December 9, 2020  
File No. 20-122

**Re: Geotechnical Engineering Feasibility Report Review  
Dungeness Off-Line Storage Facility  
River Road, Clallam County, Washington**

**Plate 4.** Shallow landslide above River Road, opposite the parking area for the Dungeness Trails park.

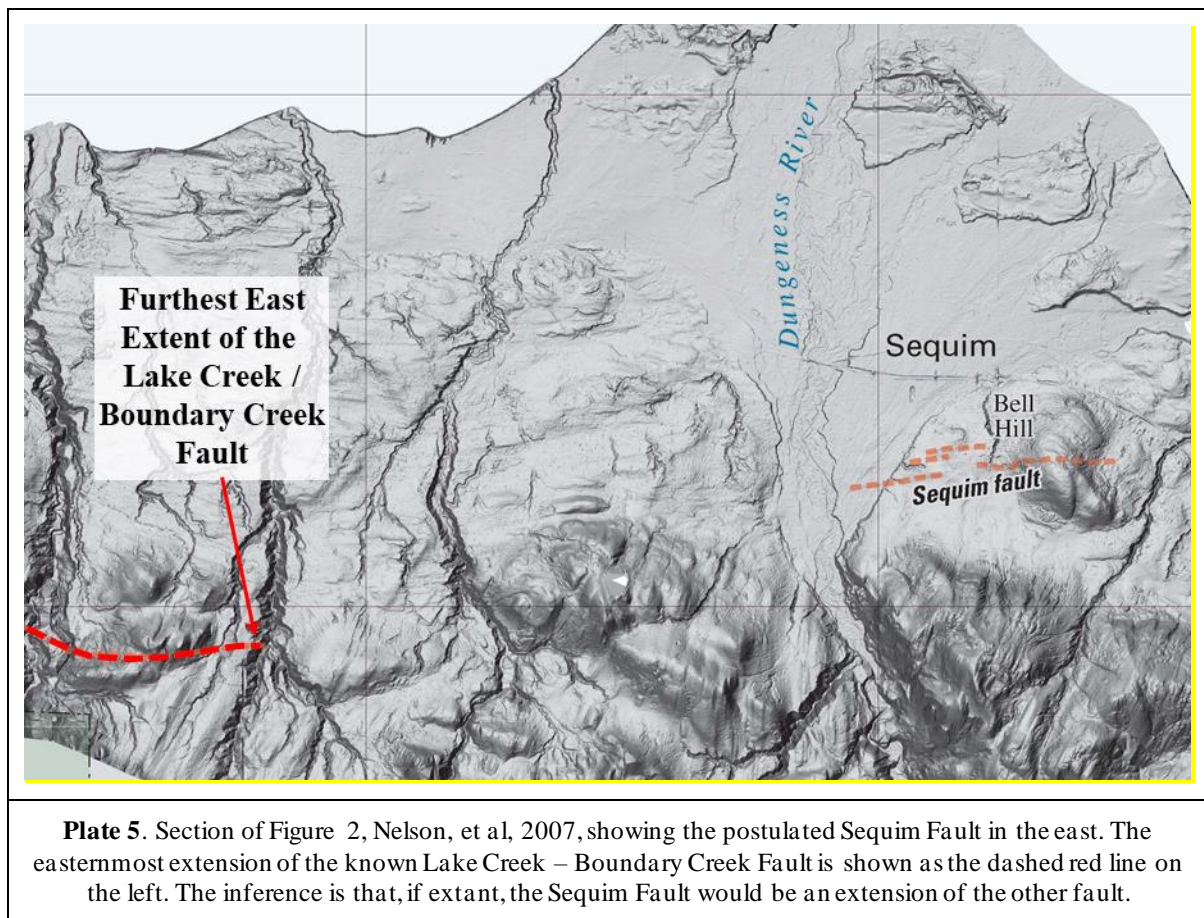
Our site reconnaissance observed one area of sliding, opposite the entry to the main entry to the parking area for the Dungeness Trails, as marked by a warning road sign on River Road. The site has recently experienced a shallow slide (see Plate 4). This small slide consisted of the slumping of surficial colluvium. A smaller slide, that did not extend to the road level, is present off the frame to the left. The entire active zone is roughly 300 feet

wide, prompting the irrigation district's use of approximately 300 feet of corrugated plastic pipe to cross areas of prior ground movement.

While we observed this small, shallow slide south of the proposed reservoir, we believe that the slide zone will not pose a hazard to the facility. Essentially, active slides in the area are shallow and we did not observe any clear evidence of deep-seated slides. Furthermore, there are no features visible on the Lidar DEM suggestive of any significant instability in the reservoir area.

As we have described, there is a landslide at the southeastern corner of the planned reservoir area. The current activity consists of a shallow colluvial slide and is not a hazard to the project. However, a slide that closed River Road could pose an inconvenience to the

operation of the facility. In our opinion only an Oso-like, long runout landslide would pose a significant risk to the facility, and such a slide is very unlikely in till soils with shallow bedrock. Even a deep-seated, rotational landslide would not greatly affect the site. If this remains a concern, a slope inclinometer could be installed to confirm the stability of the slope.

Figure No. 2

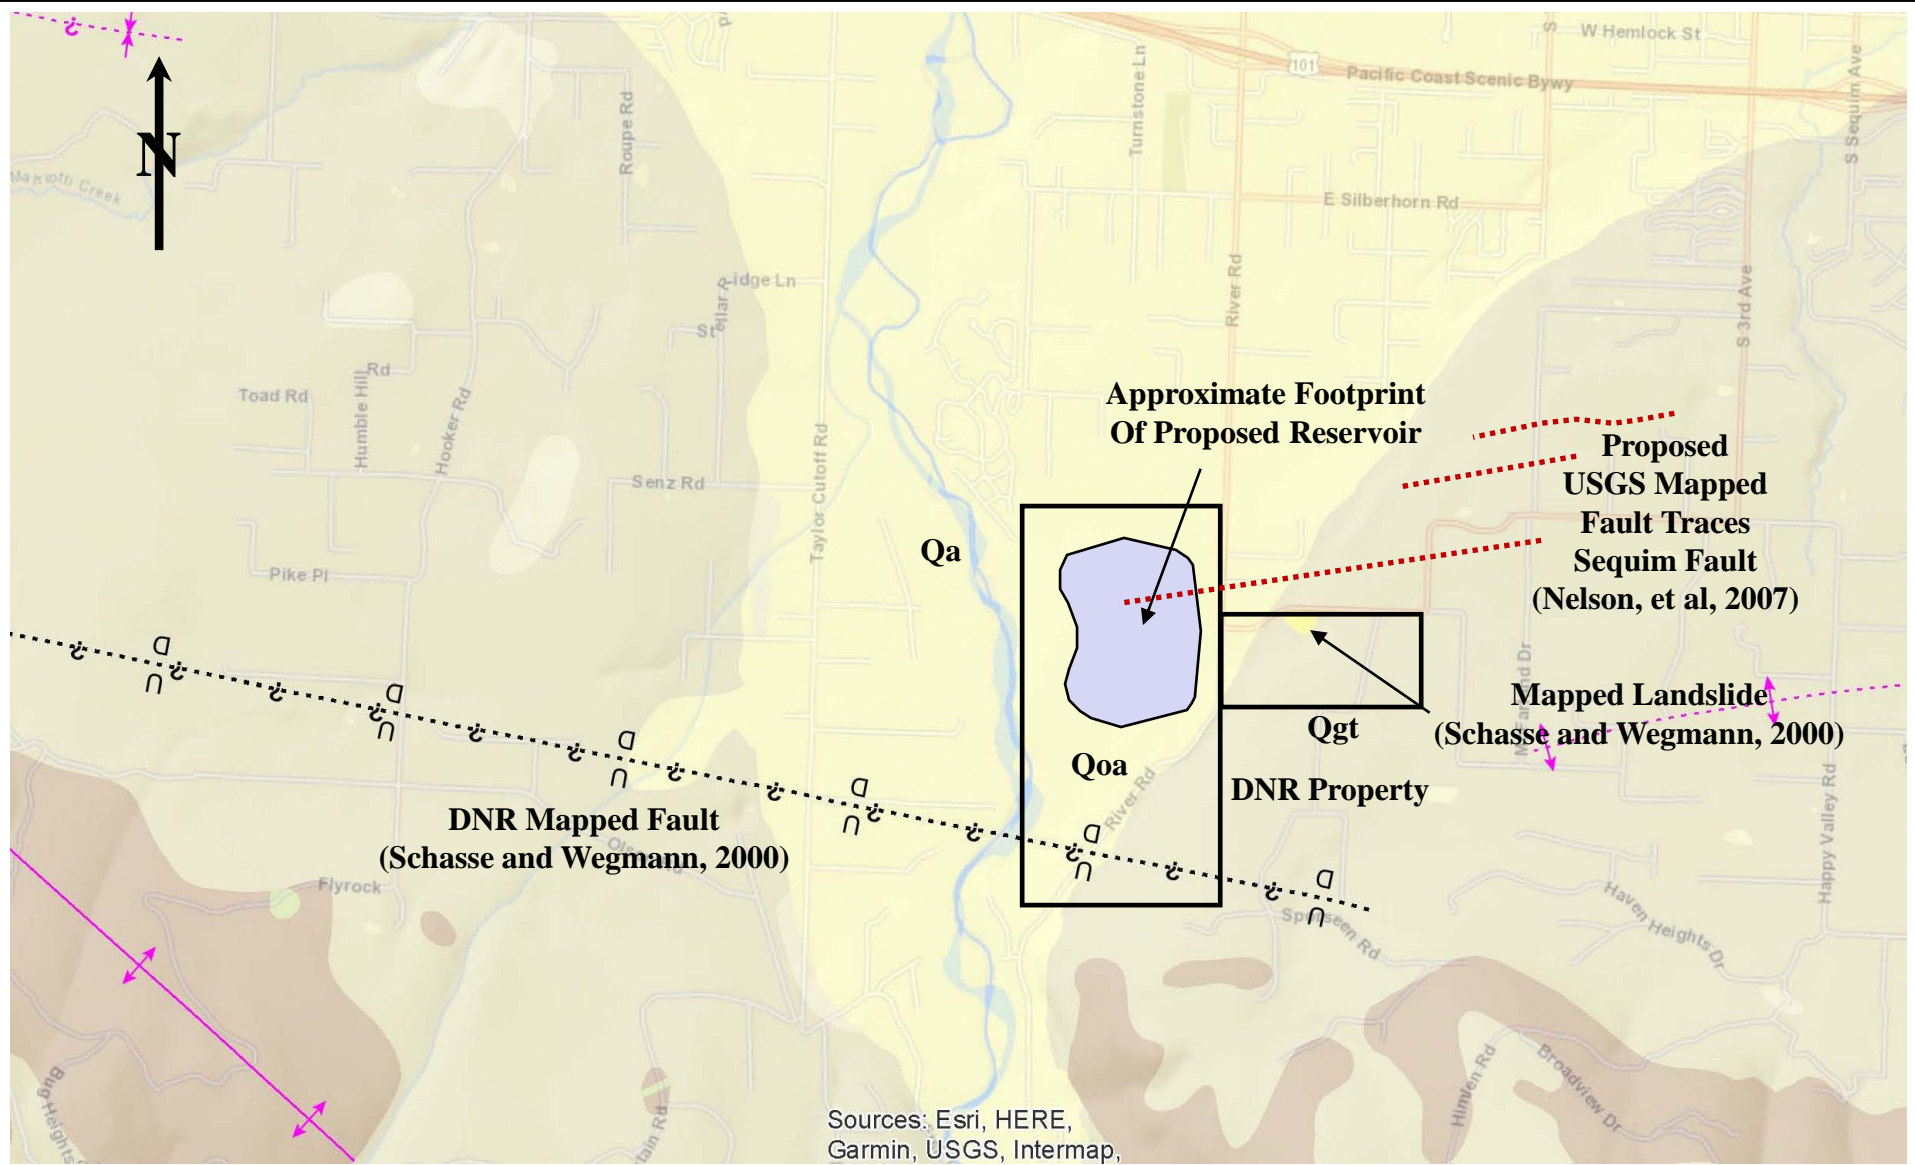
Schasse and Wegmann (2000) mapped one small landslide in the area of the proposed project. This landslide was located above Happy Valley Road as it ascended the bluff to the east of the River Road (see Figure 2). To assess the potential for landslide hazard on this site, we reviewed the Lidar imagery for the area (see Figure 3). The area was most recently flown in 2019 (Olympics South Opsw). In the DNR geological review (Shafer, 2019), the Lidar data from 2002, 2008 and 2016 was also reviewed.

Shafer (2019) concluded that there was no evidence for the landslide as mapped by Schasse and Wegmann (2000) and shown on Figures 2 and 3. However, she suggests a deep-seated landslide in the south portion of the property and postulated that the slide was in the area of the fault mapped by Schasse and Wegmann (2000). The feature we believe she identified is marked on Figure 3.

Schasse and Wegmann (2000) mapped a fault running south of the project area, which they infer as a high angle normal fault, dipping and down to the north. This fault motion would

be unusual under the general compressional tectonic regime, and we question the existence of such a fault.
